CITY PLANNING COMMISSION

The applicant is requesting the necessary entitlements to develop the first of three phases in the development of a new Kaiser-Permanente Medical Center consisting of an interconnected 112 bed hospital and 73,500 sq.ft. of offices. Phases two and three will require further review under the Special Permit procedure.

APPLC. NO. P82-150

CONCEPTUAL LANDSCAPE PLAN 1/8"=1'-0"

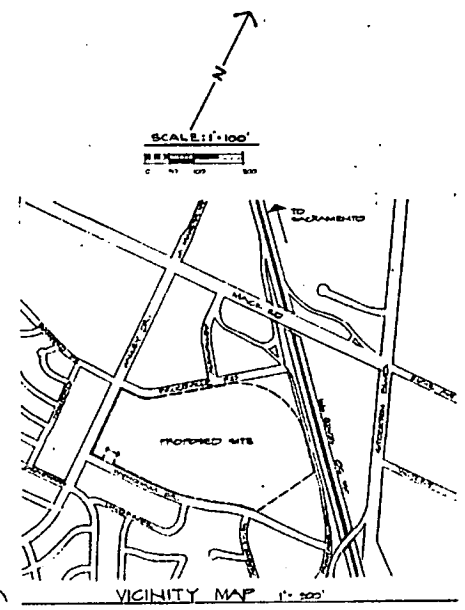
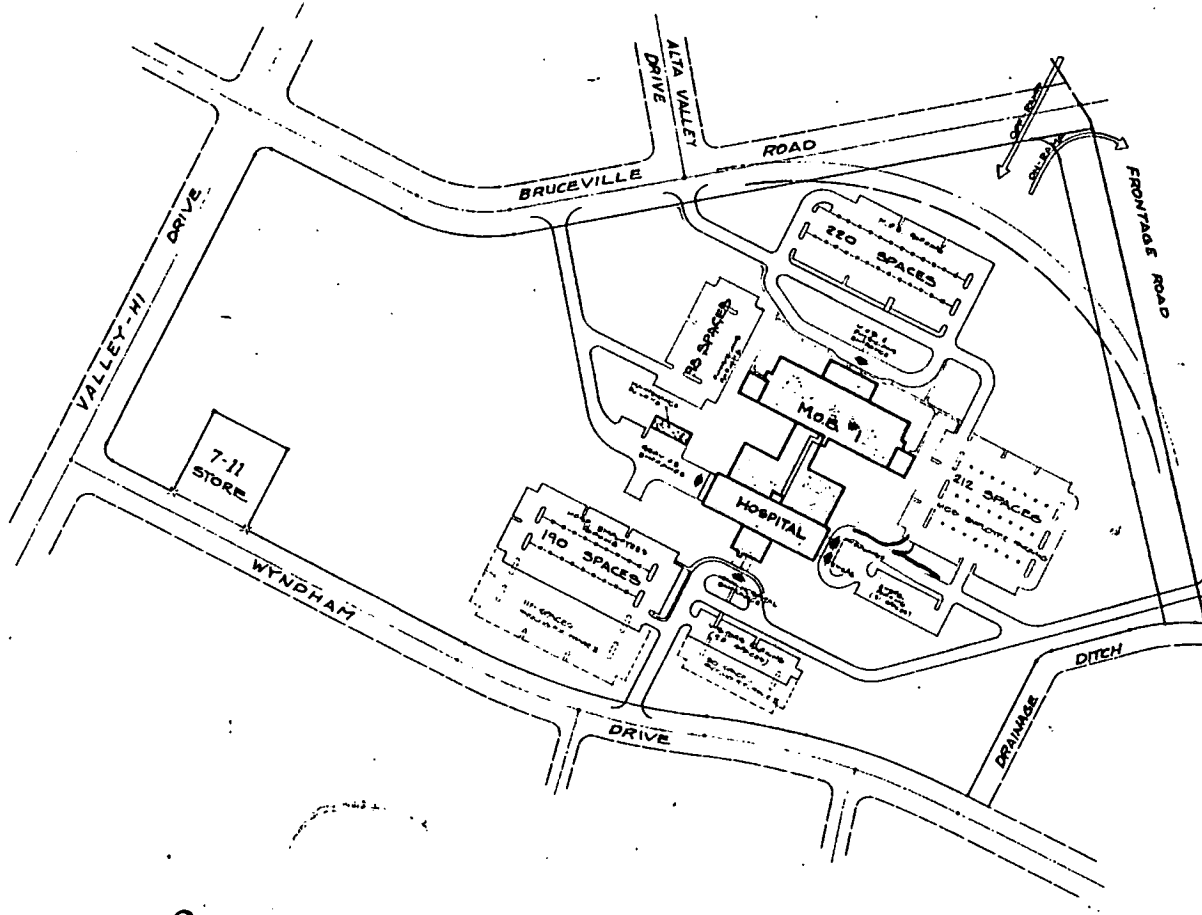
Staff's concern relative to the on-site circulation is the access and visibility to the emergency entrance (see site plan). In order to reduce the circuitous internal approach, and to direct individuals to the emergency entrance, staff recommends a direct connection to the emergency entrance loop as shown on Exhibit "A" as well as a directional signage program.

- d. Setbacks: The Hospital zone requires a minimum landscaped setback of 25 feet from all property lines abutting public streets. The northernmost parking lot and the area designated for future parking lot expansion in the south must be revised to reflect this setback prior to issuance of building permits.

In addition to the standard landscaped and irrigated areas the plan indicates that certain areas will be hydroseeded only and not irrigated. Staff find the hydroseeding appropriate for these areas reserved for future expansion, but not the required 25-foot setback area adjacent to the Bruceville Road realignment north of the northermost parking lot nor those areas adjacent to Wyndham Drive south of the parking lots. Exhibit "A" indicates those areas which should be fully landscaped and irrigated in addition to those areas proposed by the applicant.

25 foot landscaping & irrigation required

Reserved for future expansion (irrigation not required at this time)

connection Required between parking lot and emergency loop

25 foot Landscaping & irrigation required

5. The existing off-site signs shall be removed prior to the issuance of building permits.
6. The site plan shall be revised to include a setback of 25 feet from all property lines abutting public streets prior to the issuance of building permits. (See Exhibit "A").

- a. Additional landscaped areas as indicated on Exhibit "A".
 - b. Compliance with the City's 50-percent shading requirement for surfaced areas;
 - c. A variety of tree, shrub and plant types. Tree and shrub sizes shall range from 15 gallon to one gallon sizes.

CONCEPTUAL LANDSCAPE PLAN 1"=60'-0"

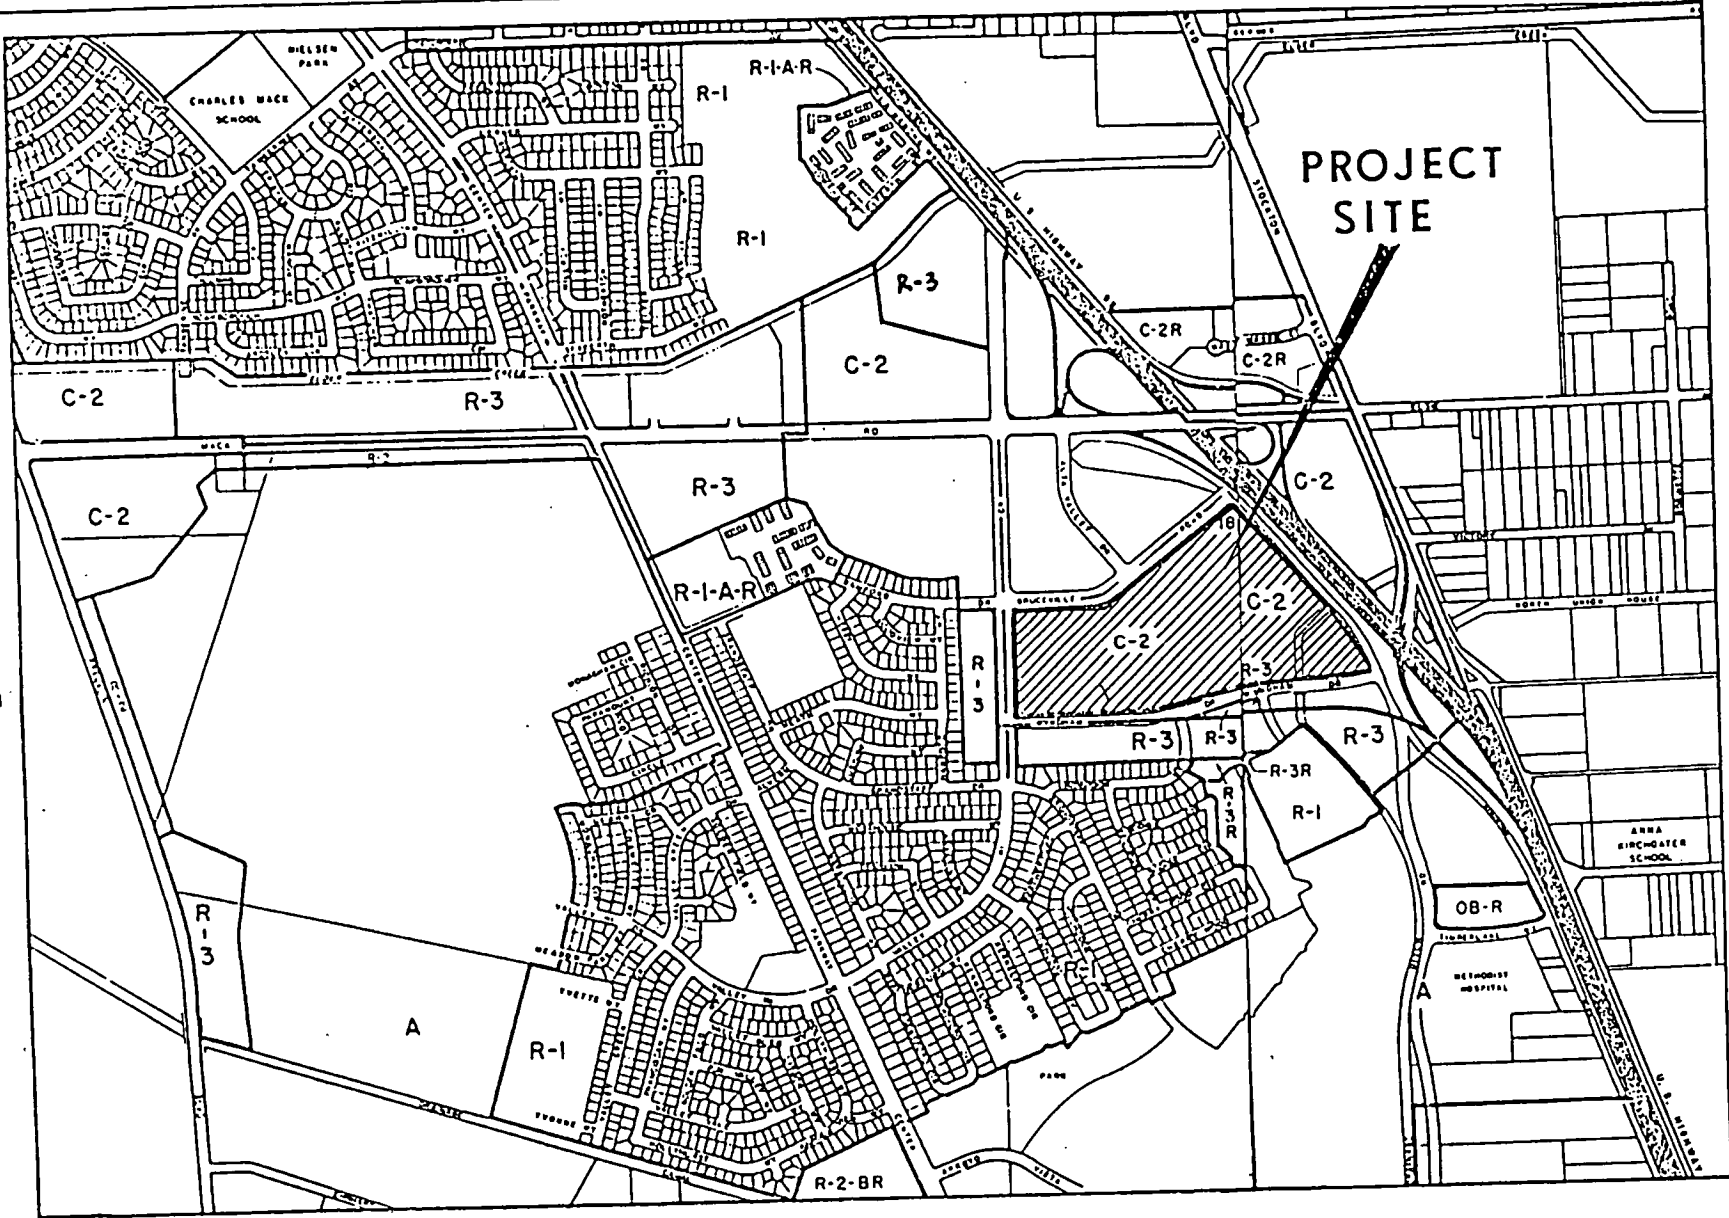
25 foot landscaping & irrigation required

Reserved for future expansion
(irrigation not required at this time)

connection required between parking lot and emergency loop

25 foot Landscaping & irrigation required

PRELIMINARY LANDSCAPE BUFFER STRIP
SOUTH SACRAMENTO MEDICAL CENTER
Kaiser Foundation Hospitals
SACRAMENTO, CALIFORNIA

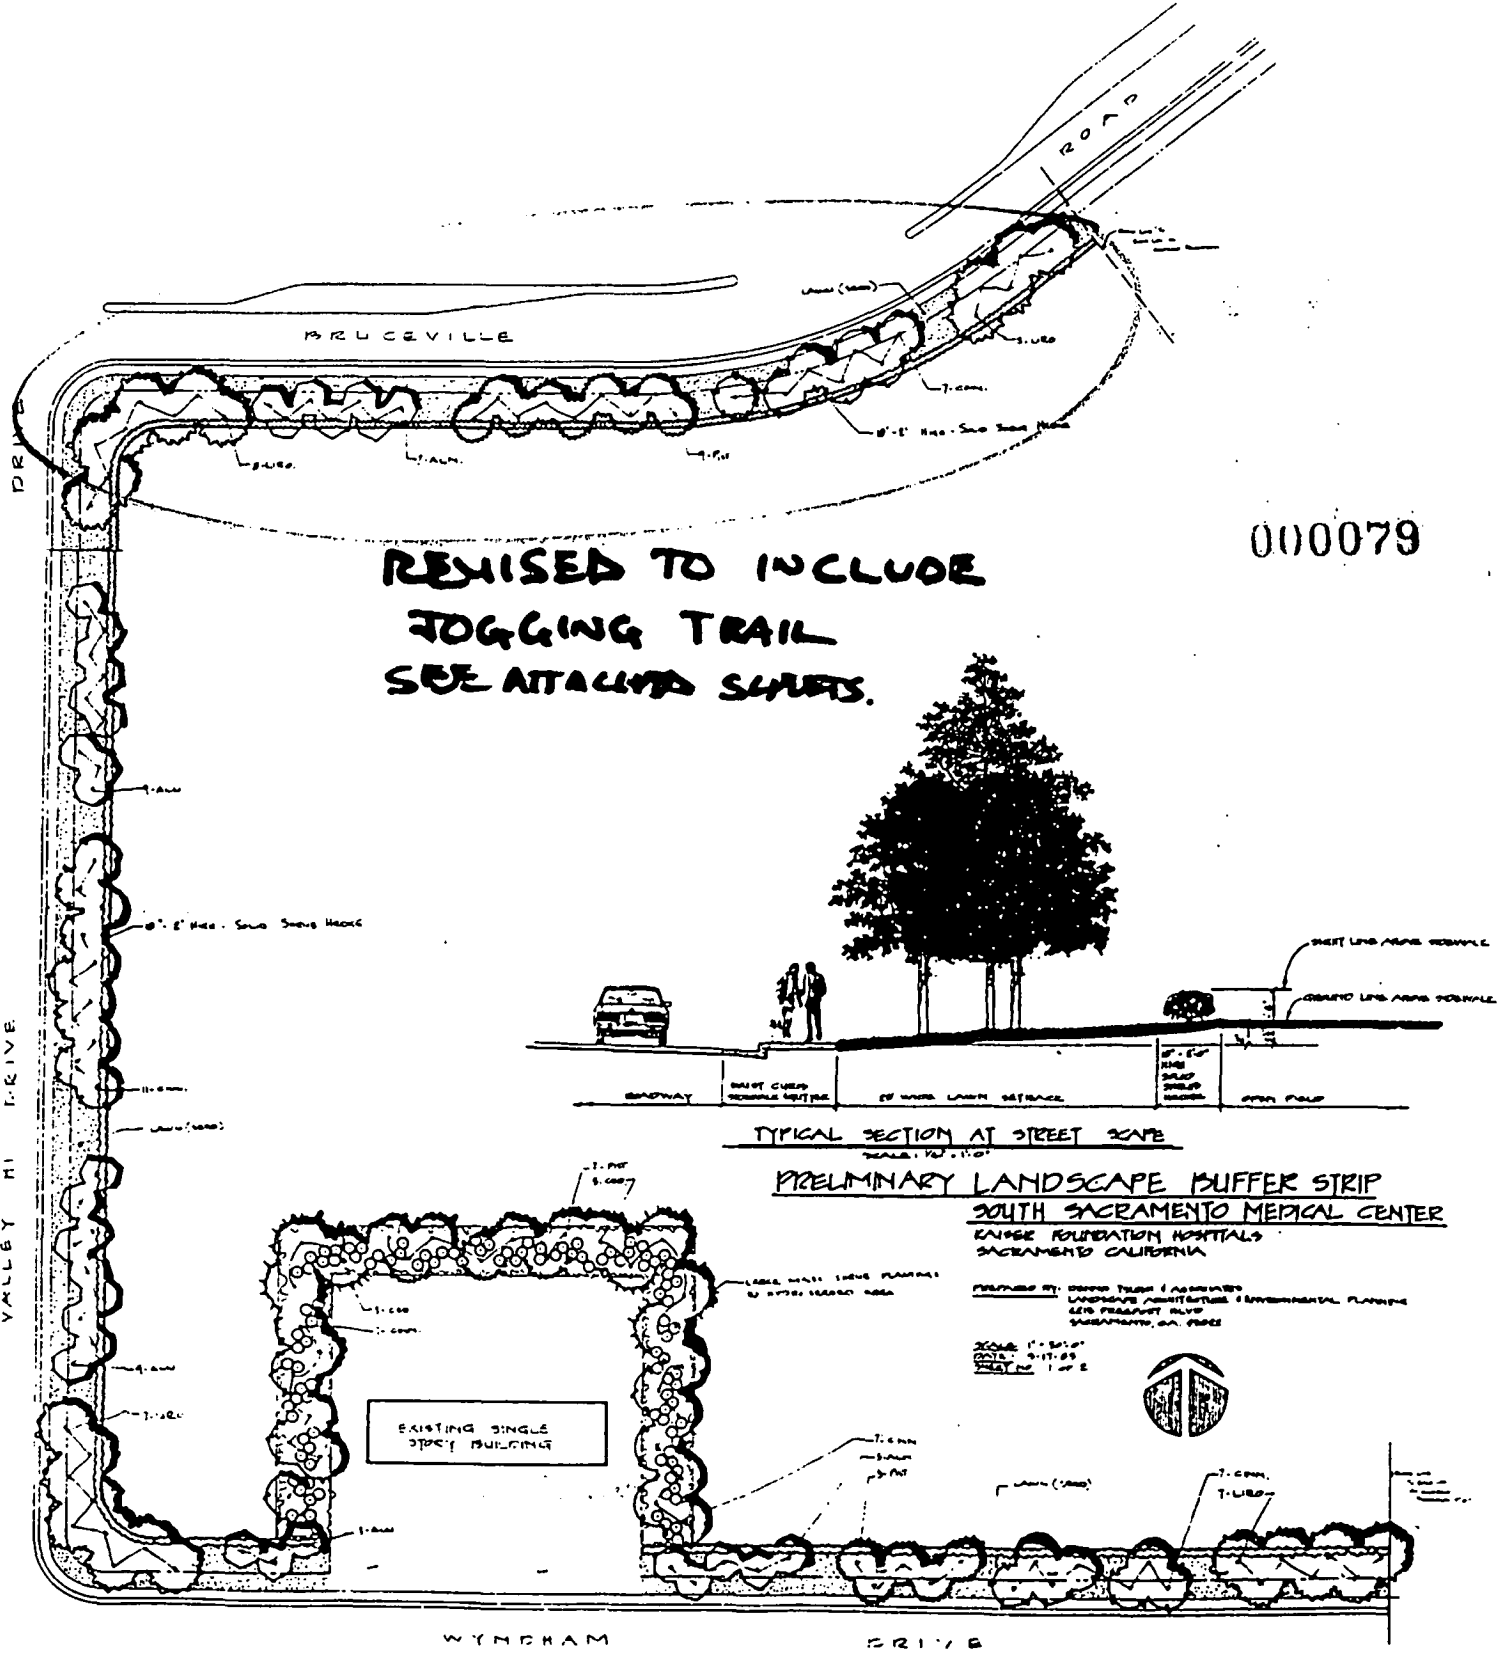
REVISED TO INCLUDE
JOGGING TRAIL
SEE ATTACHED SHEETS.
